| ITEM # | QTY | SHEET # | NEWMAR # | DESCRIPTION                      |
|--------|-----|---------|----------|----------------------------------|
| 1      | 1   | 1       | 132029   | UNIVERSAL PAN 8 13/16 X 12 11/16 |

|                                                                                         | Title:<br>UNIVERSAL PAN 8 13/16 X 12 11/16 | I.D. # SLIDE<br>OUT PARTS\<br>PAN_132029 | Date:<br>7/9/14    | Date:<br>5/9/16      | ITEMS #7 AND #8 AS #6 AND #7 RESPECTIVELY                                    | Date: 4/20/17 |

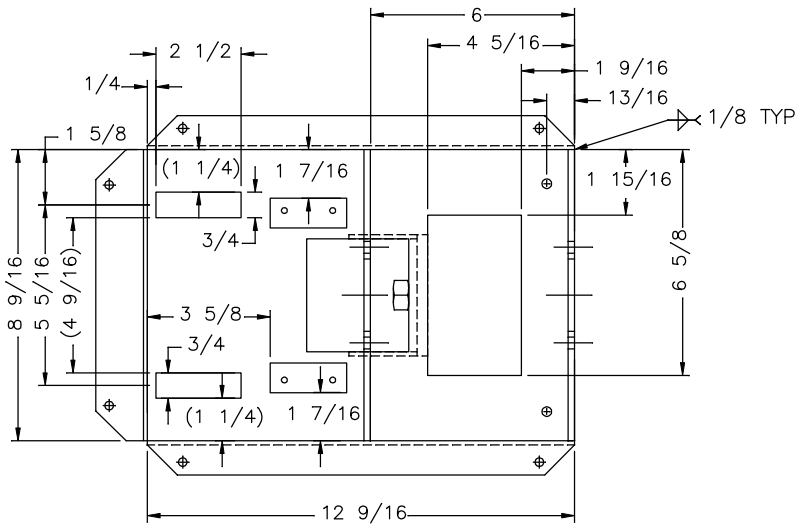
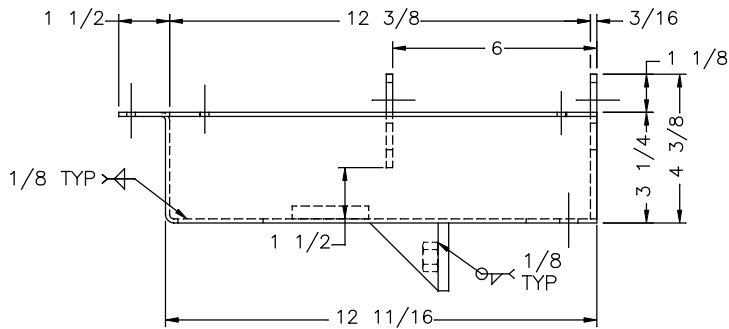
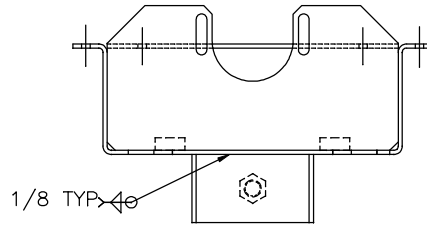
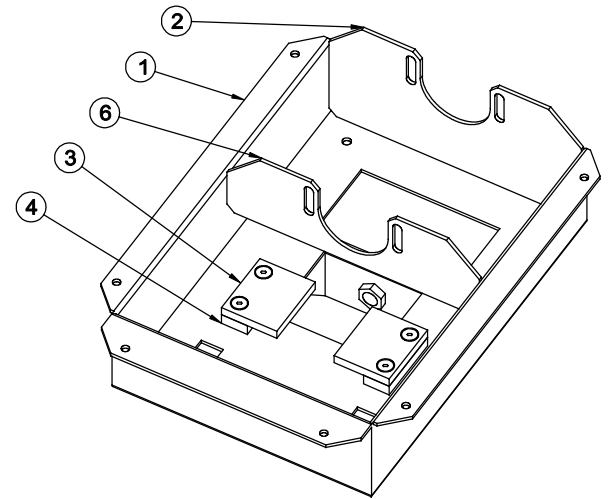
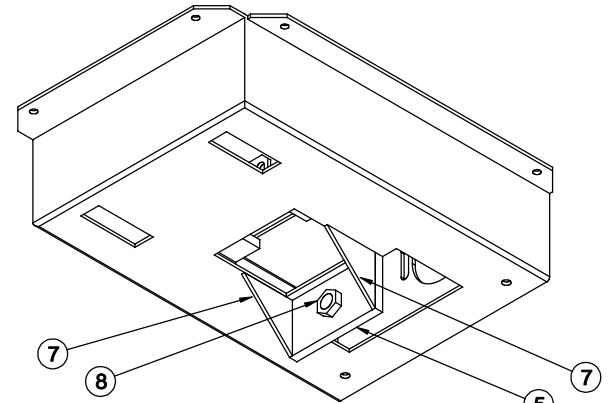
| ITEM #                                                                       | QTY REQ'D | SEE SHEET | DESCRIPTION |
|------------------------------------------------------------------------------|-----------|-----------|-------------|
| Revision: CORRECTED ITEM NUMBERS TO IDENTIFY 1/2-13 NUT AS #8, PREVIOUS      |           |           |             |
| ITEMS #7 AND #8 AS #6 AND #7 RESPECTIVELY                                    |           |           |             |
| Revision: REVISED PAN CONSTRUCTION TO INCLUDE GUSSETS TO KEEP LOWER TAB WITH |           |           |             |
| NUT PERPENDICULAR TO PAN BOTTOM SURFACE DURING ROOM ADJUSTMENT (ECO #140)    |           |           |             |
